The concept roundabout design for the intersection of Appin Road/Church Street (prepared by GTA Consultants, Drawing No. 14S1076000-06-01-P3, Sheet 1 of 1, dated 29.01.15) has been reviewed using the current RMS design reference documents. RMS notes that the roundabout design has been based on the old RTA 'Roundabouts – Geometric Design Method'. RMS raises no concerns with this in principle as it is acknowledged that the Austroads Roundabout Design Guide radii would be excessive for this location. RMS does however advise that this non-conformance will require sign off prior to construction/finalisation of the Works Authorisation Deed by the RMS Director of Engineering and as such the non-conformance cannot be signed off on at this time.

Existing public footpath located within Lot 1 DP 507820

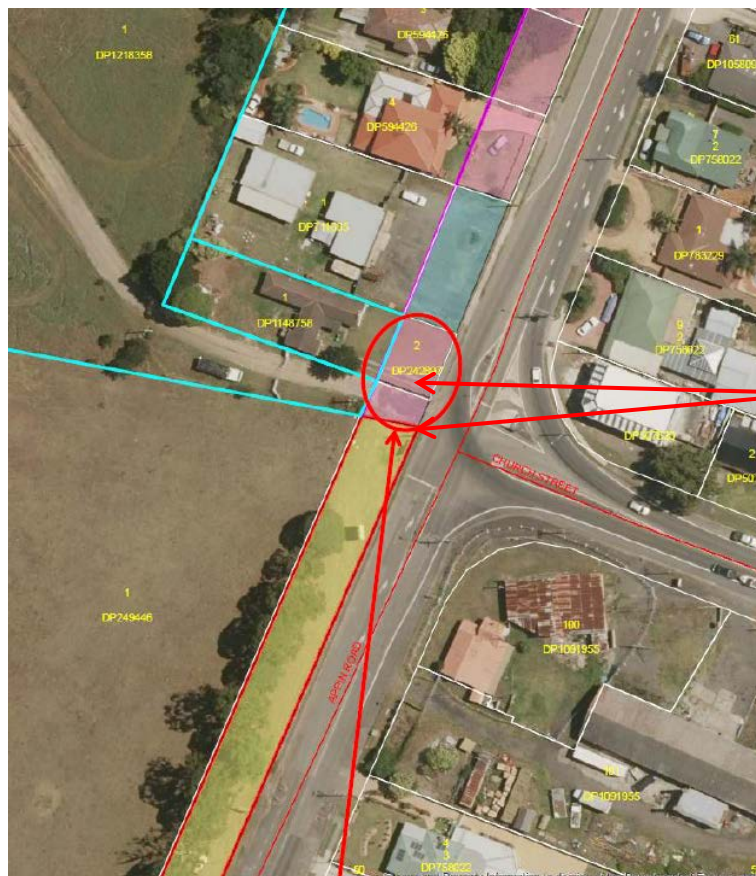
- The existing intersection arrangement has part of the northeast cadastral boundary within the road reserve (e.g. the footpath is located within Lot 1 DP 507820 – refer to aerial photo below). This issue will continue to stand with the submitted concept roundabout design. The roundabout location should be adjusted to avoid the above cadastral conflict. Alternatively, if the roundabout location is to remain as shown on the concept plan the developer will need to provide details on how this cadastral property issue can be resolved;
- Sight distance Criterion 1, 2 and 3 in *Austroads Guide to Road Design Part 4B: Roundabouts* must be addressed. The submitted design does not currently address these
